ADDENDUM 02 COVER PAGE

Project: Sonoma Clean Power 421 E Street Tenant Improvement 421 E Street Santa Rosa, CA 95404	Owner: Sonoma Clean Power Rebecca Simonson 431 E Street Santa Rosa, CA 95404 projects@sonomacleanpower.org	Arch Job # 1207 Date: July 7th, 2025
---	---	---

ADDENDUM 02

This addendum consists of Three (3) pages dated July 7th, 2025.

421 E STREET
ROOFTOP PHOTOS

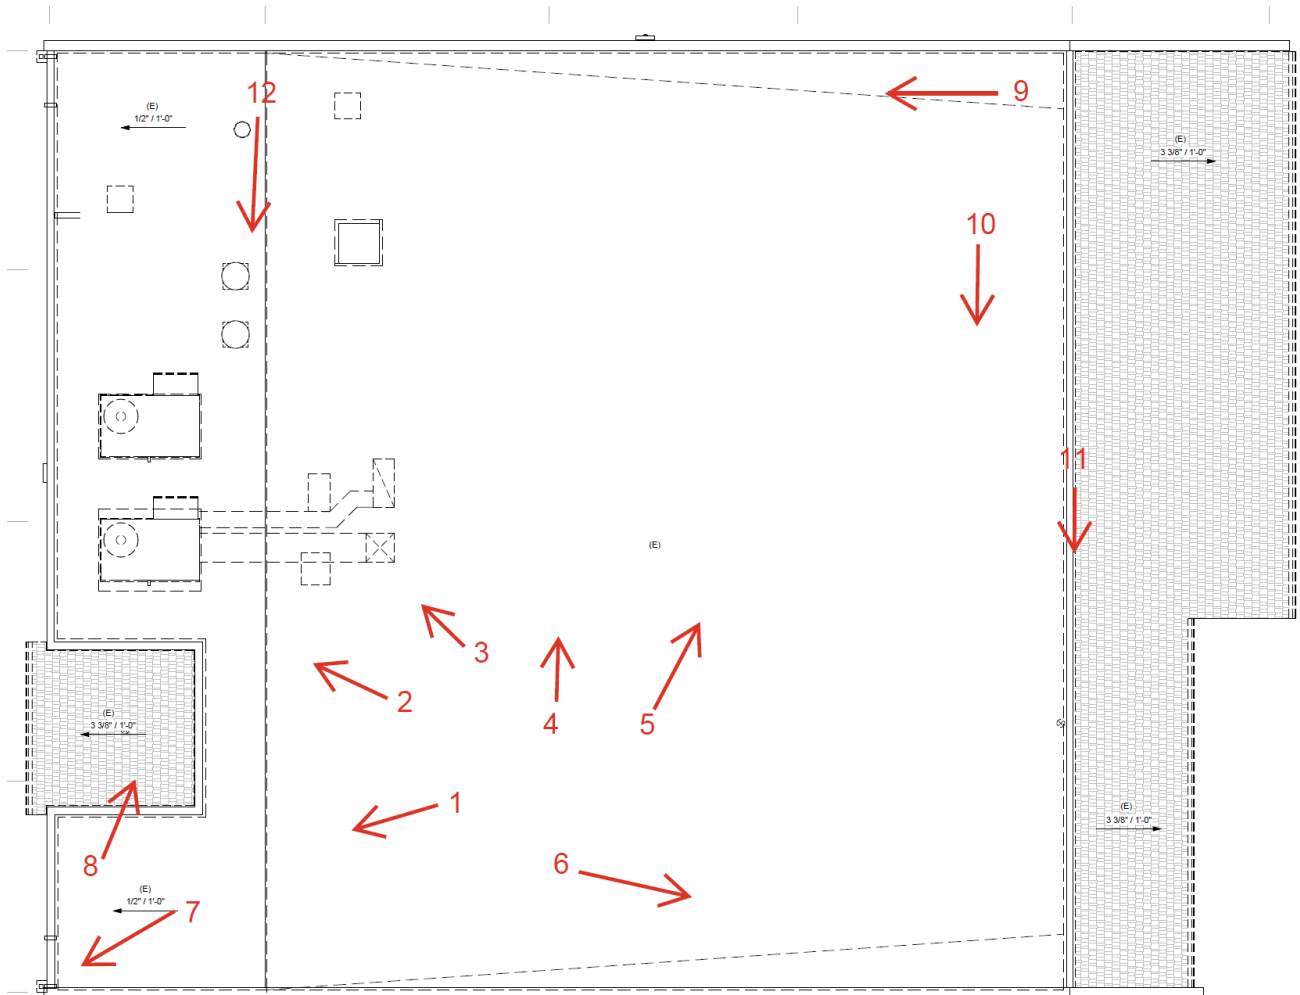
ADD 02.06: Question: Can you show pictures of the rooftop?

Answer: See document 421_E_Street_Existing_Rooftop_Photos.PDF. For Reference Only. Refer to additional Non Mandatory Pre-Bid access on July 10th, 2:00 pm to 4:00 pm.
